McCULLOCH CORPORATION
SERVICE BULLETIN

1511

MODEL: Mini-Mac 6®

SUBJECT: Manual Oiler Check Valve, P/N 86438

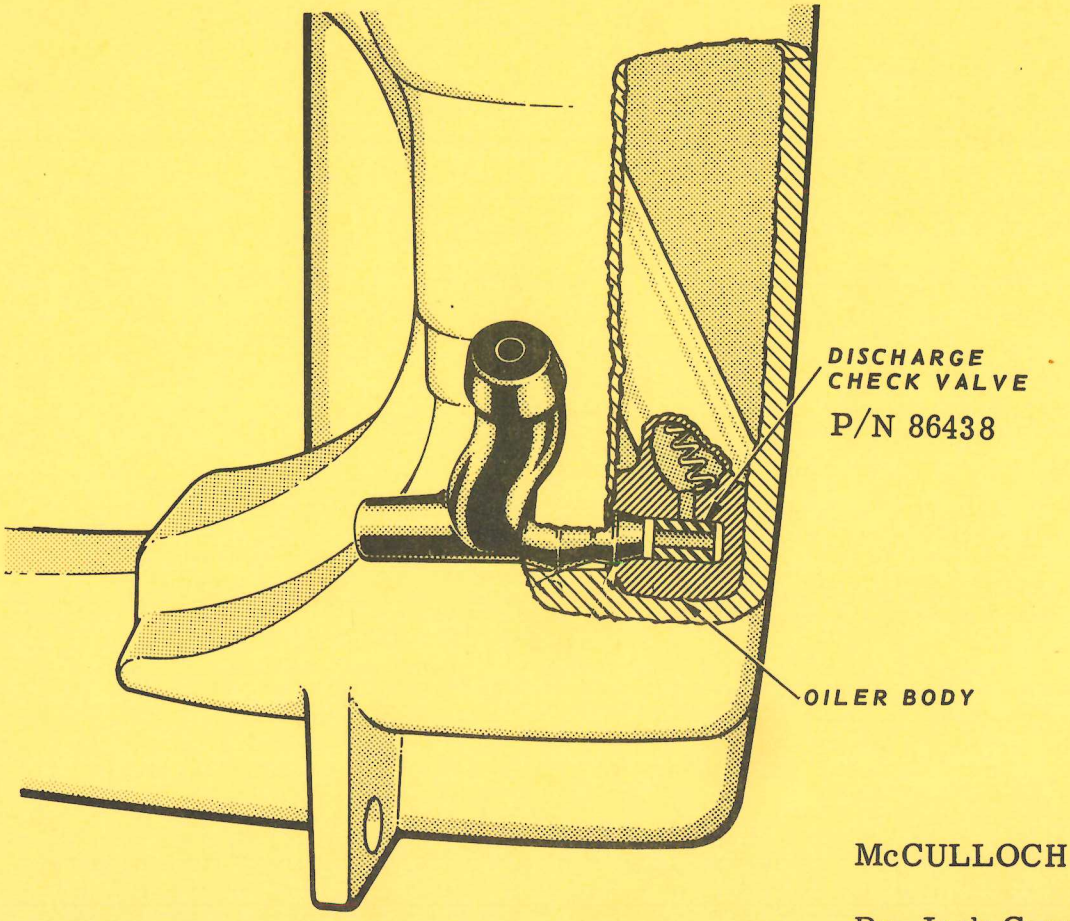
A new manual oiler check valve, P/N 86438, with greater resistance to gas and oil is now available for the Mini-Mac 6 . This new valve is GRAY in color for purposes of easy identification.

The new valve is installed in all Mini-Mac 6 engines above serial number 11-31798.

Should you service a manual oiler assembly on engines below serial number 11-31798 for oil leakage, it is recommended that this new check valve be installed.

Below is an illustration showing the location of the Mini-Mac 6 manual oiler check valve.
